Video Products Technical Bulletin 30-2003-003

SUBJECT: **PREVENTING CAPACITOR ON D1 BOARD FROM TOUCHING REAR BRACKET**

MODEL: **PVM-20L5**

Figure 1

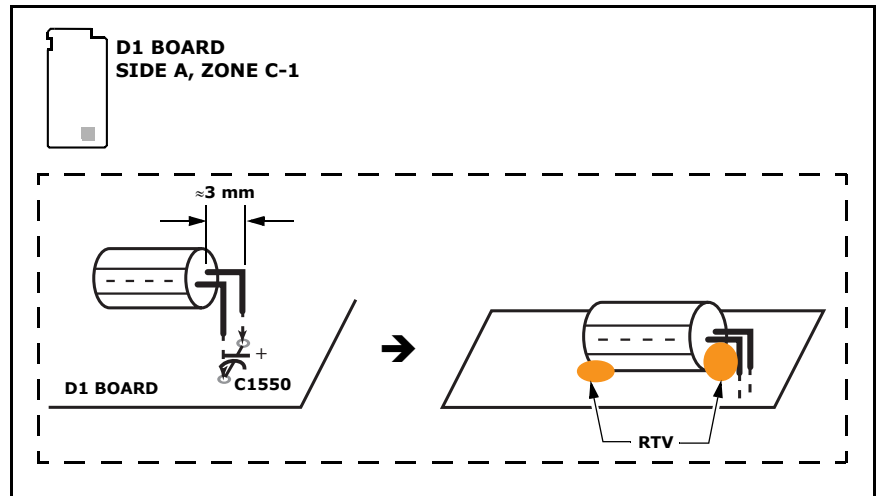
To prevent C1550 on the D1 board from touching the rear bracket, perform the following modification procedure.

D1 Board (Side A, Zone C-1)

1. Replace C1550 with a new 1000 μ F capacitor as shown in Figure 1.
2. Affix the capacitor to the board with RTV.
